Item No.83 GEARBOX SELECTOR FORK - 3rd & Top. JAVELIN & JUPITER

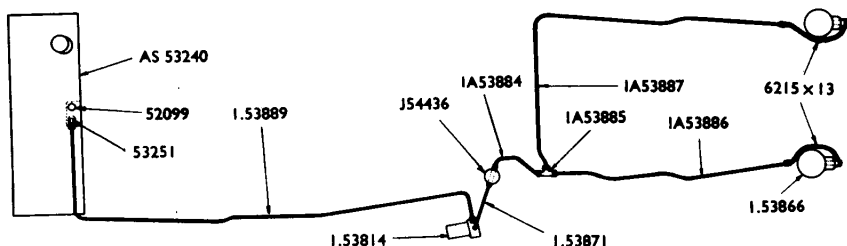
The petrol pipe layout was modified to suit the new position of the petrol pump and filter as shown in the illustration below.
